**SOLICITATION ADDENDUM NO. 2**

**ITB 20-0032**

**West Tualatin View Elementary Sewer Replacement**

Beaverton School District  
West TV Sewer Replacement  
Addendum  
April 9, 2021

Drawing Name:  
CIVIL SITE PLAN

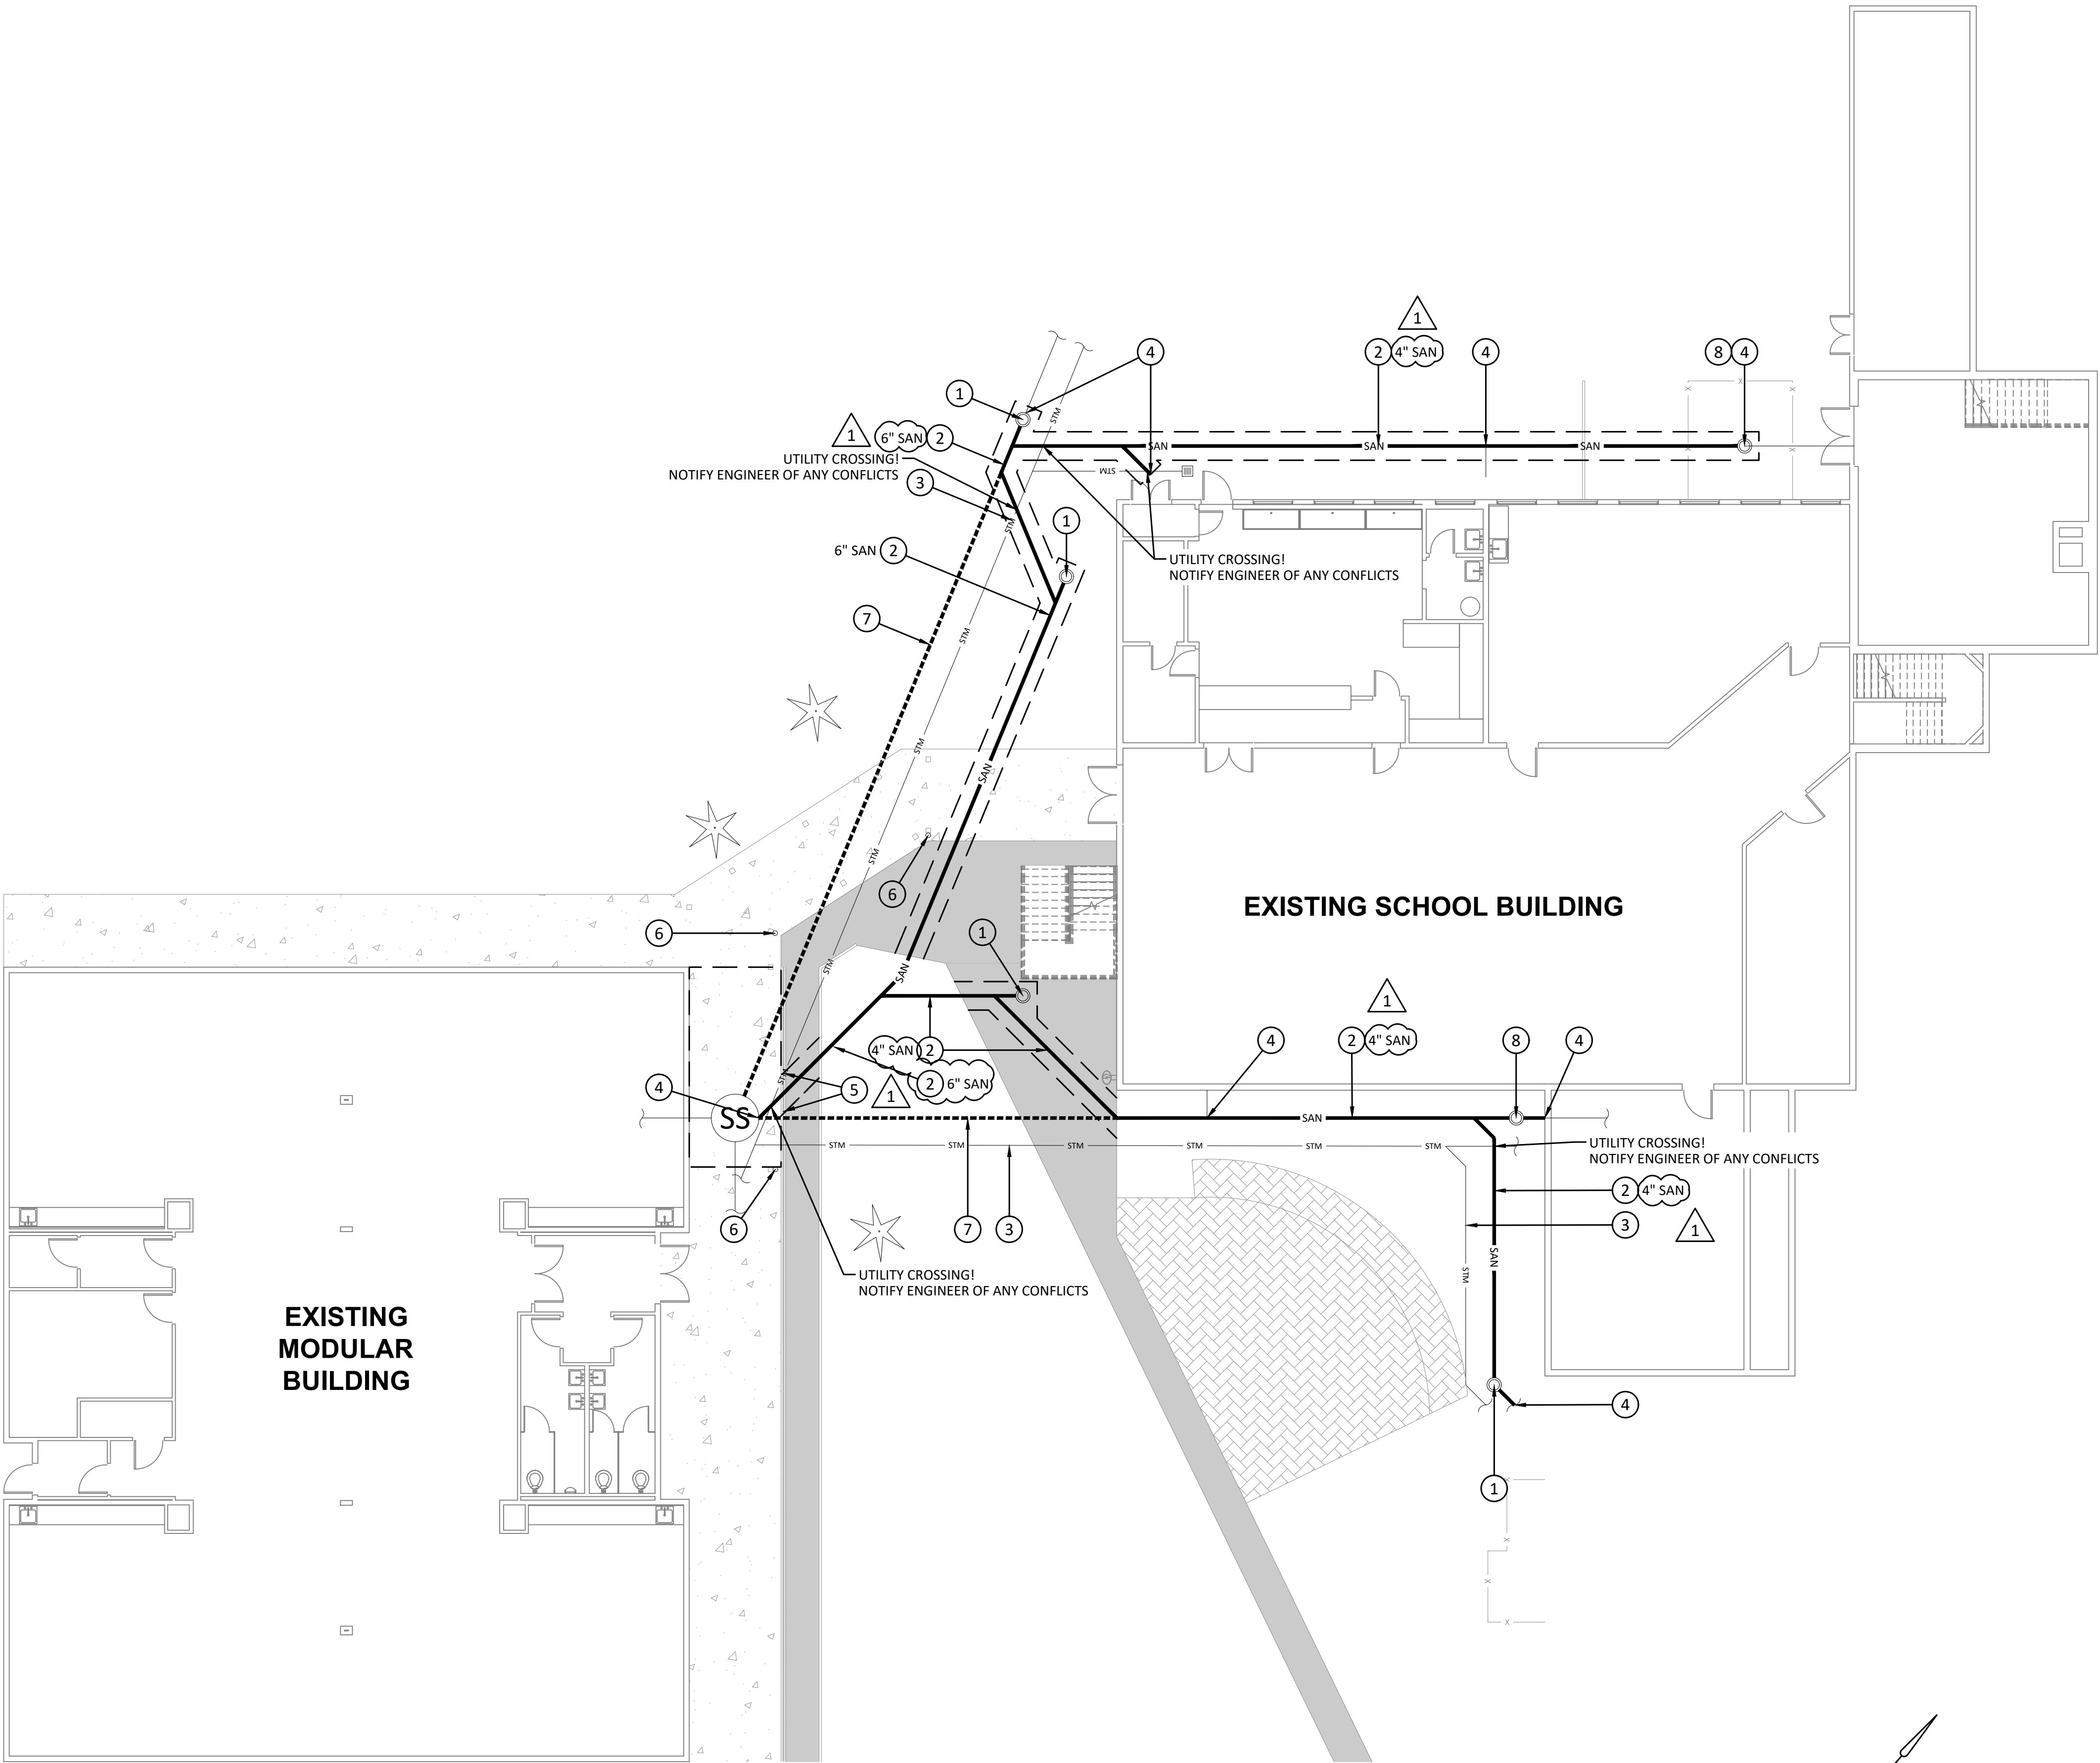
QUESTION: The main level on the civil drawings seem off in regards to the basement; please clarify.  
ANSWER: The piping was shown in the correct location. The fencing around the mechanical equipment was not shown in the correct location. Refer to the revised drawings C100 and C200 for revised fence locations. Reference CHANGES 1) noted above.

1. Drawing C100 – CIVIL SITE PLAN:
  - a. **MODIFY** the location of the fencing around the mechanical equipment.
  - b. Refer to attached revised C100 drawing.
2. Drawing C200 – UTILITY PLAN:
  - a. **ADD** pipe diameters to proposed sewer lines.
  - b. **MODIFY** the location of the fencing around the mechanical equipment.
  - c. Refer to the attached revised C200 drawing.

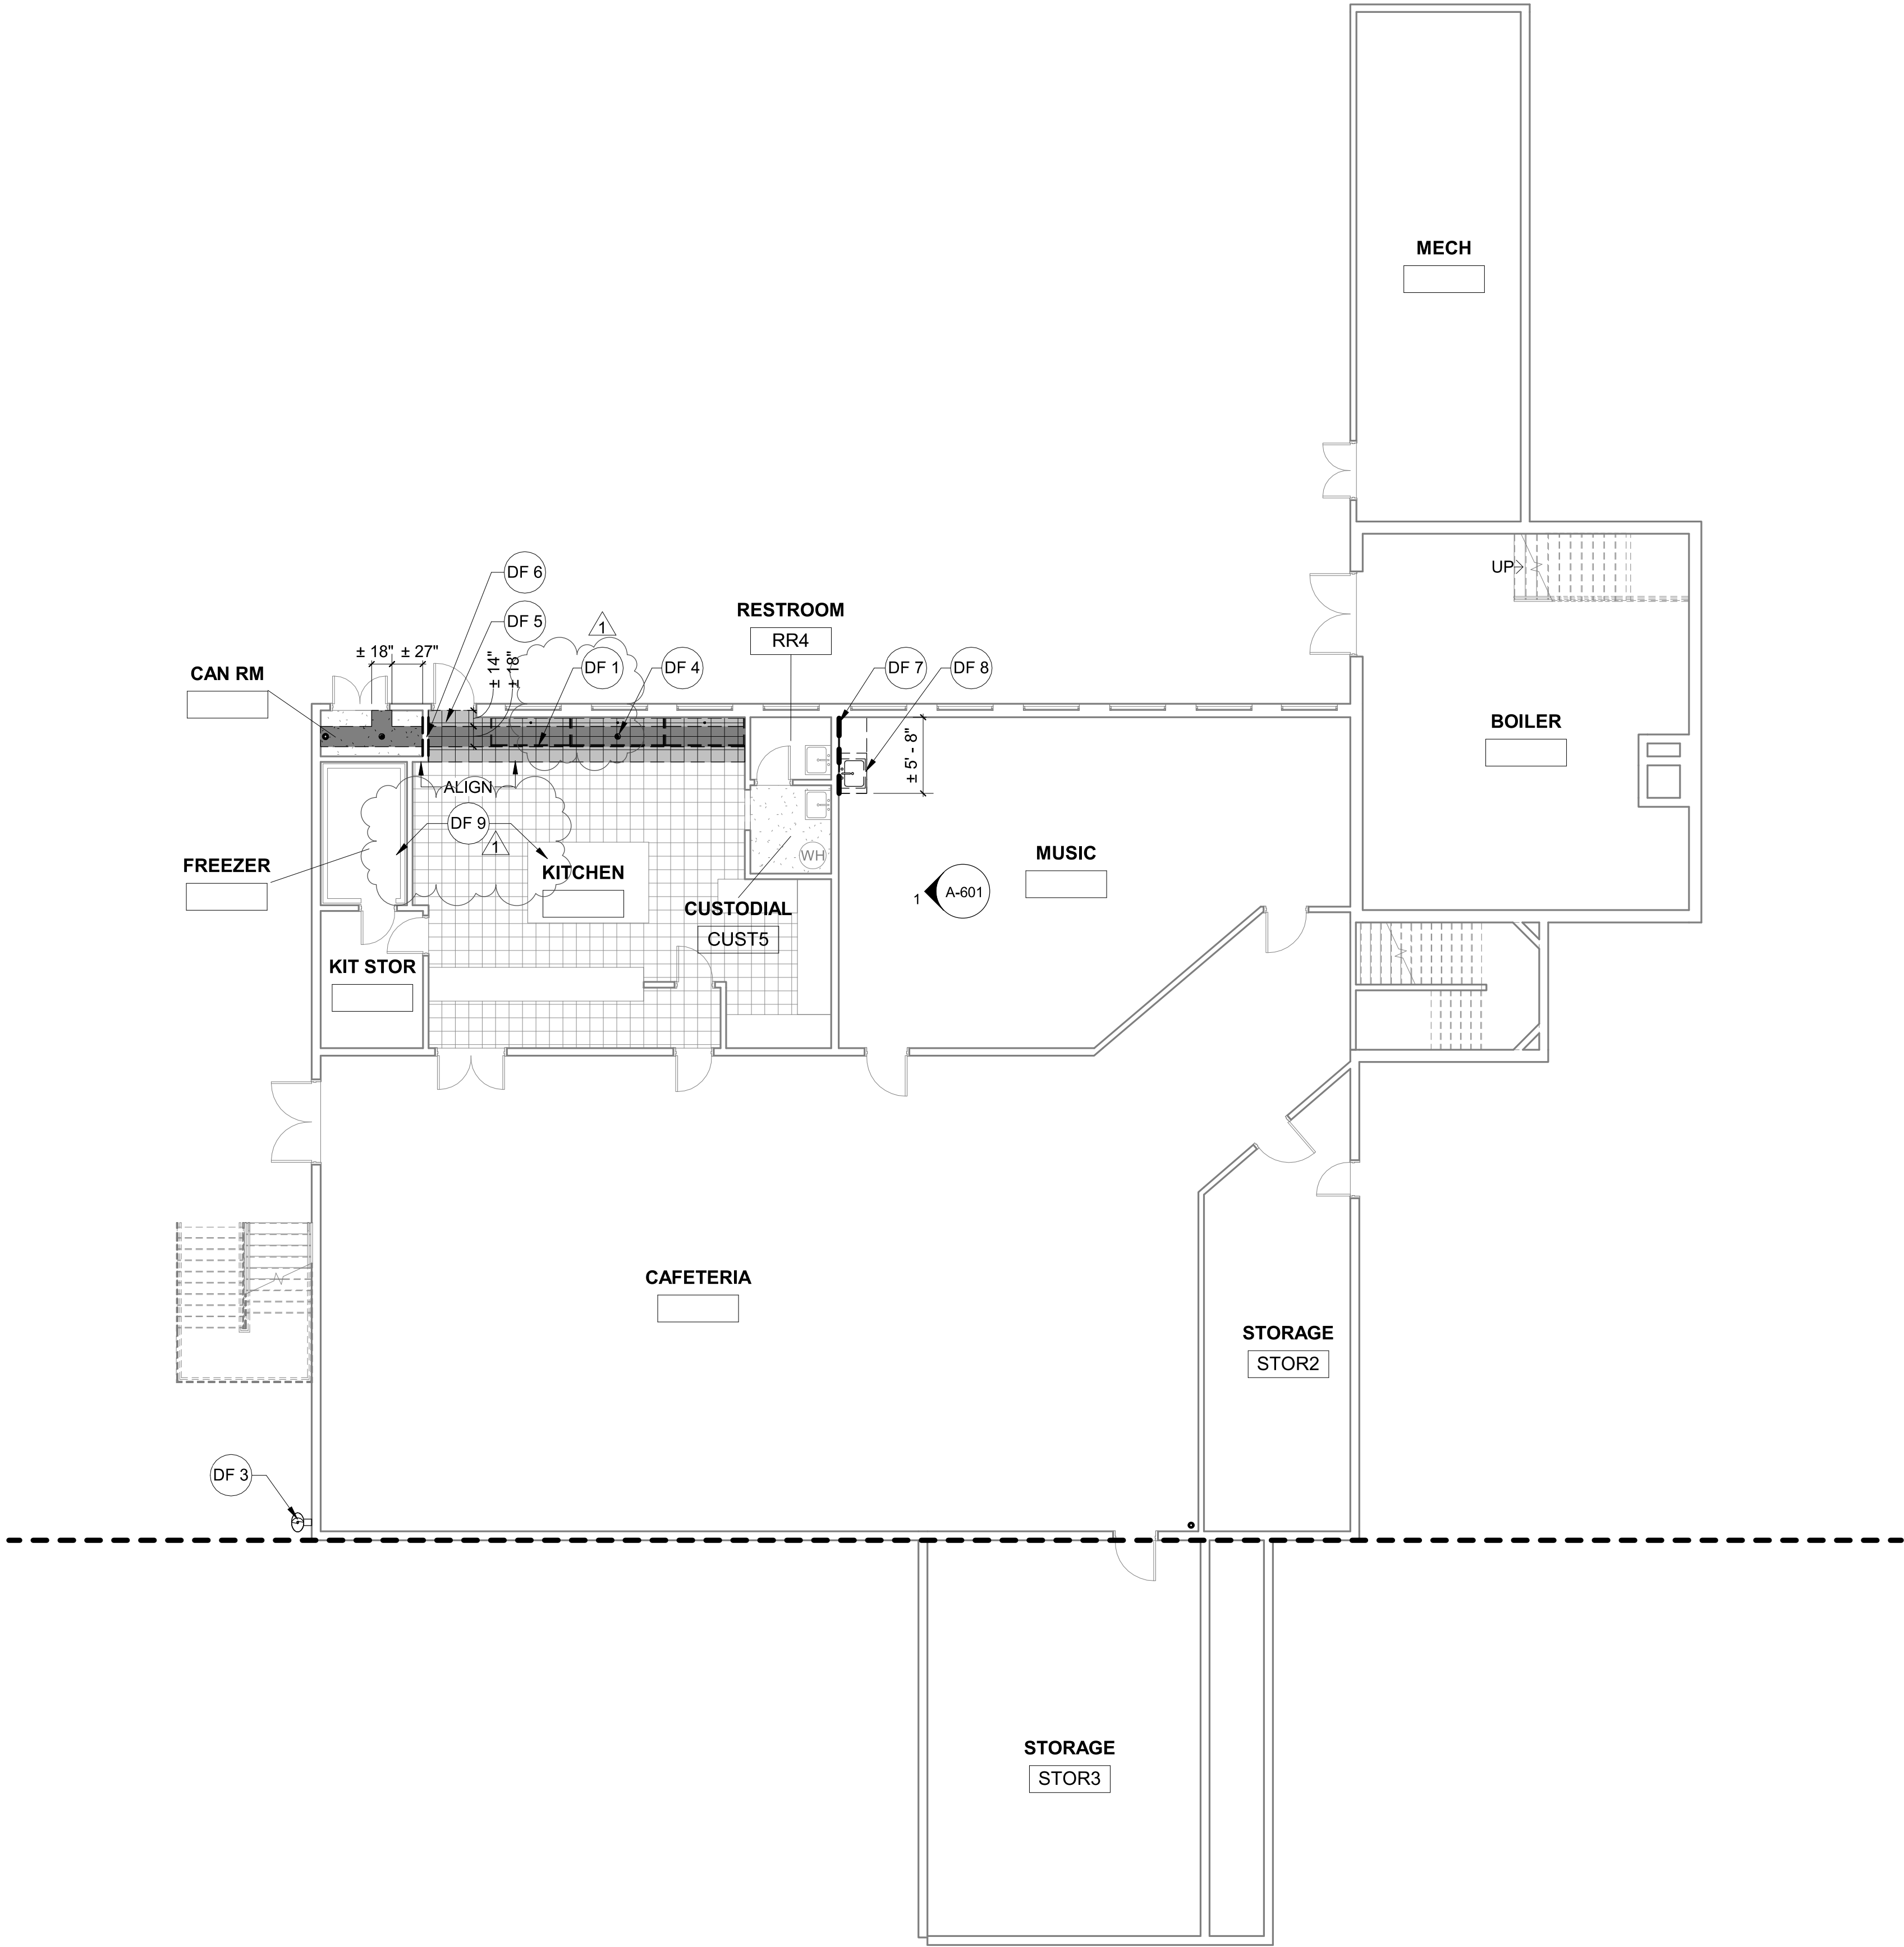
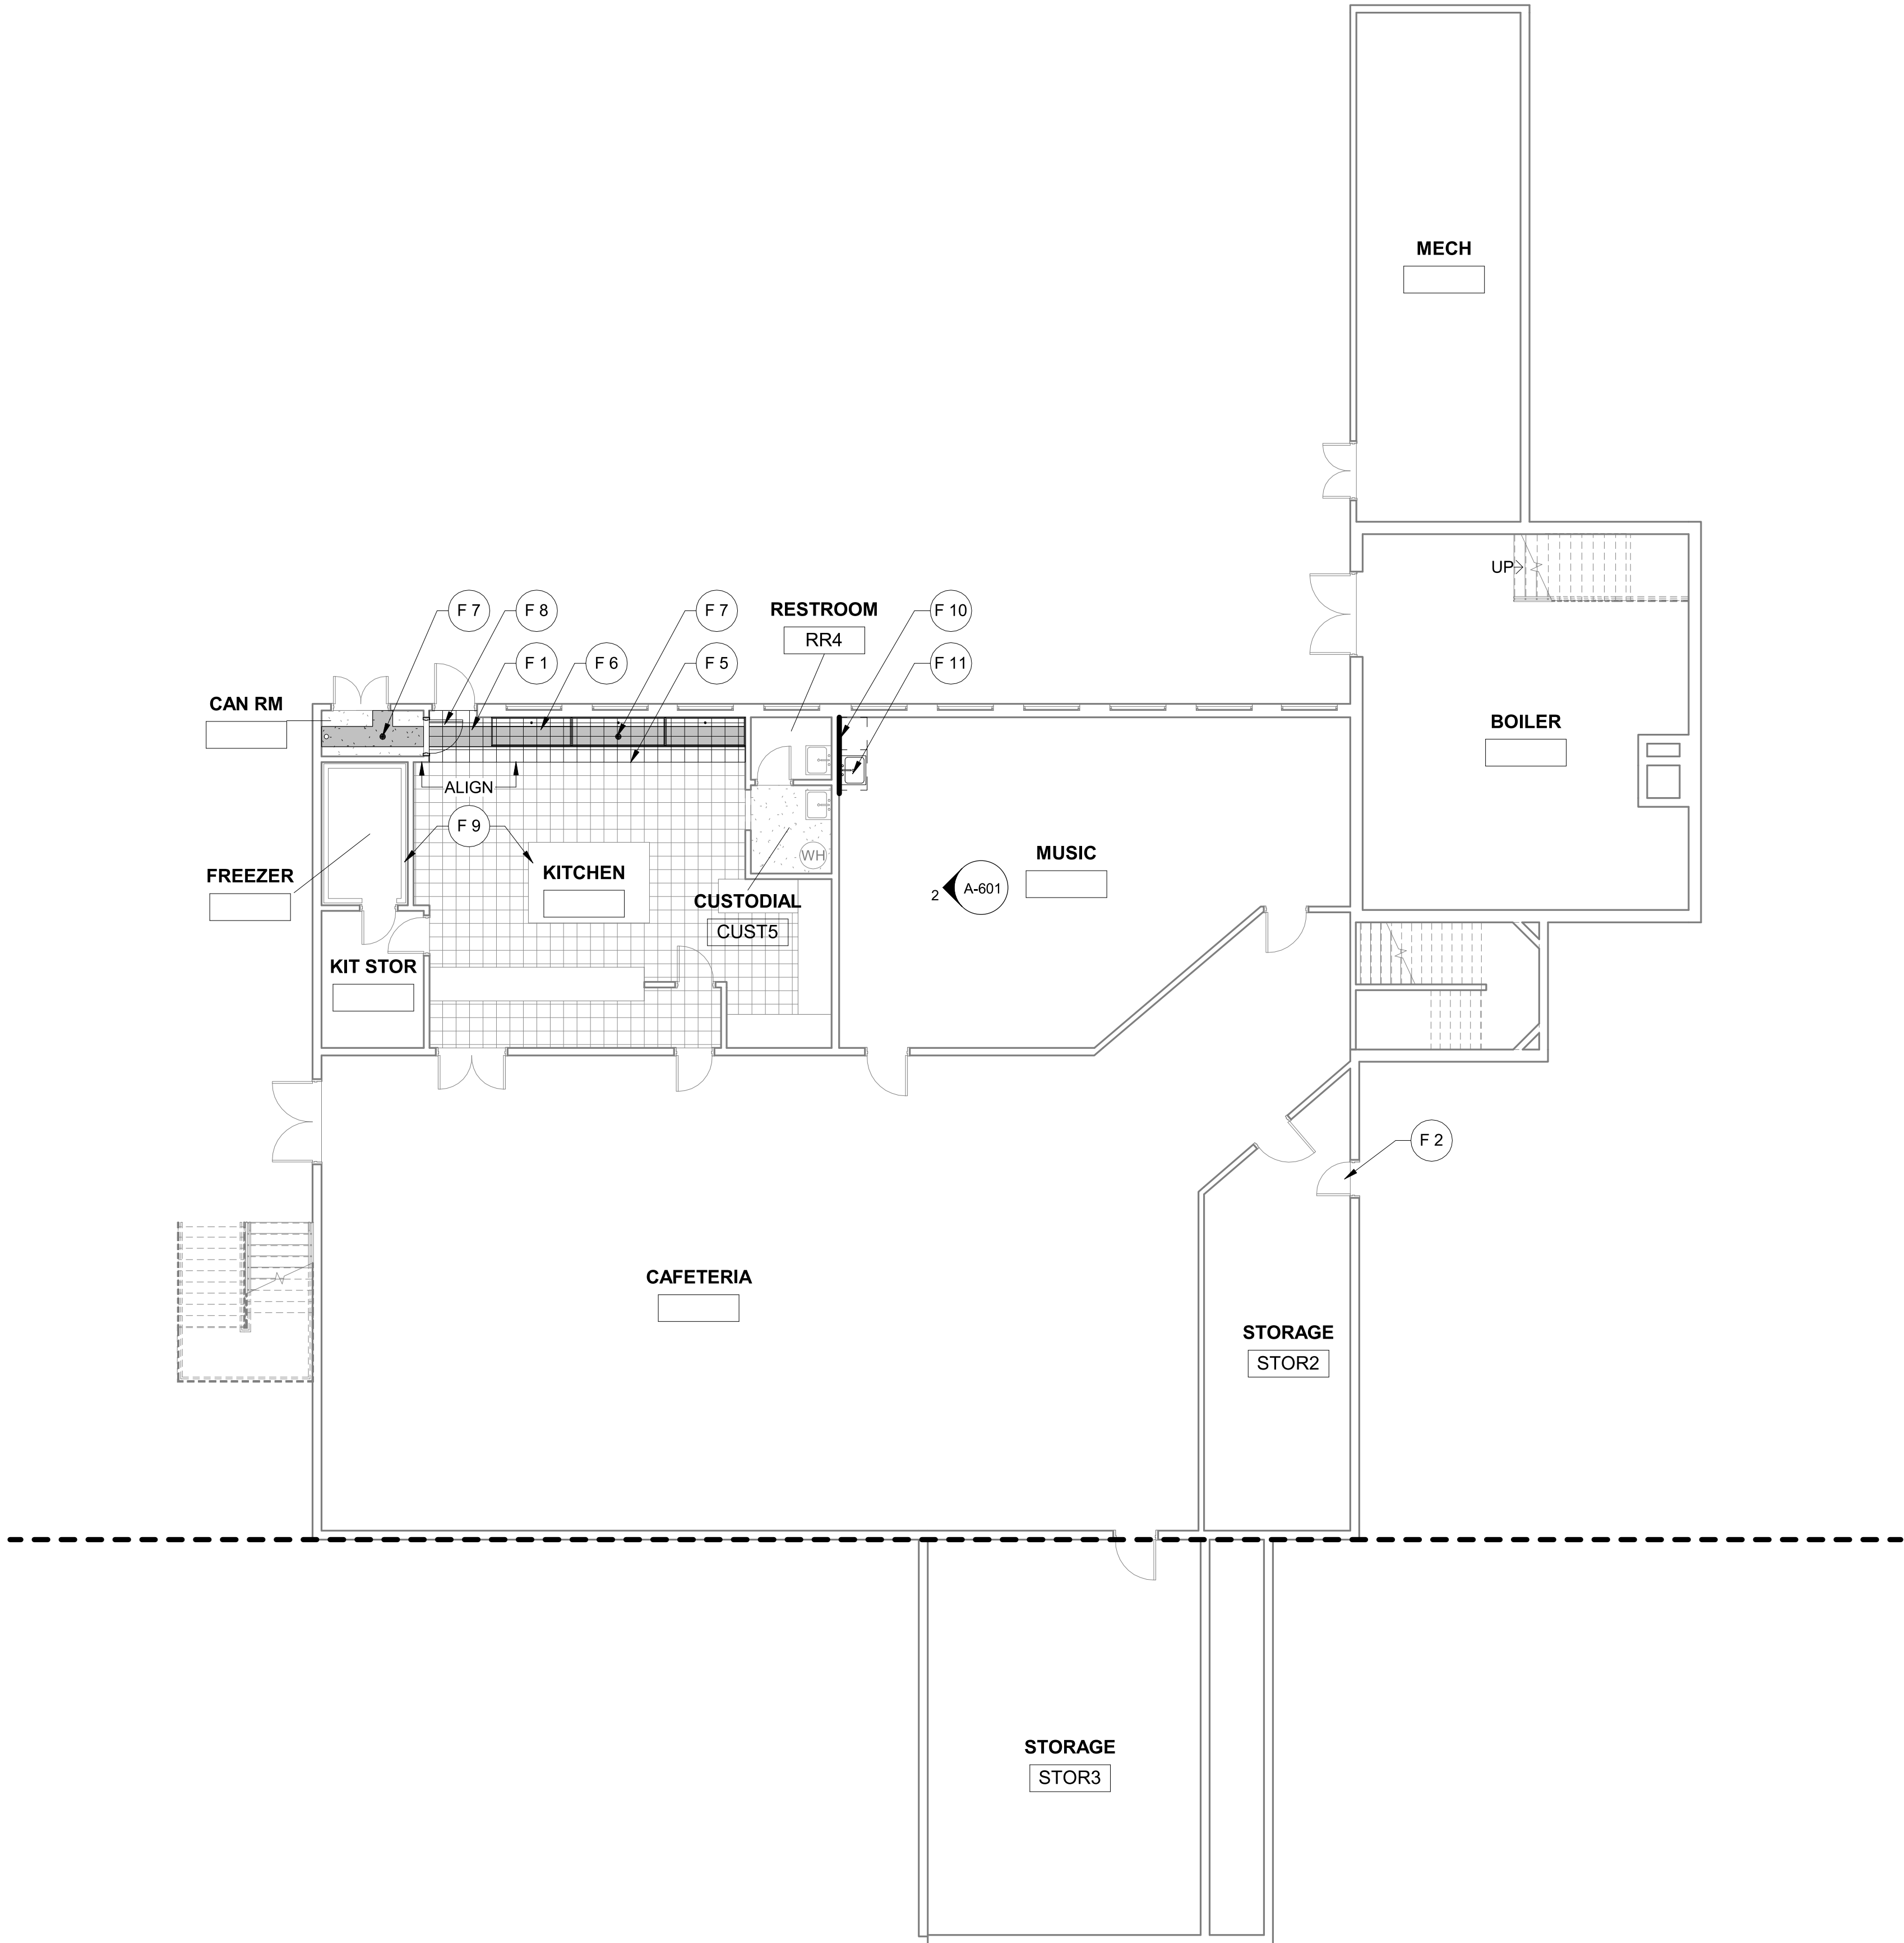
1. Drawing AD-203 – DEMOLITION BASEMENT FLOOR PLAN – AREA E
  - a. **MODIFY** keynote DF 1 to read “(E) Kitchen sinks to be removed, salvaged, and protected during construction.”
  - b. **ADD** keynote DF 9 “(E) Freezer, Prep Station, Range Hood to be protected during construction.”
  - c. Refer to attached full size sheet AD-203.
2. Drawing A-203 – DEMOLITION BASEMENT FLOOR PLAN – AREA E
  - a. **MODIFY** keynote F 9 to read “(E) Freezer, Prep Station, Range Hood to be protected during construction.”
  - b. Refer to attached full size sheet A-203.
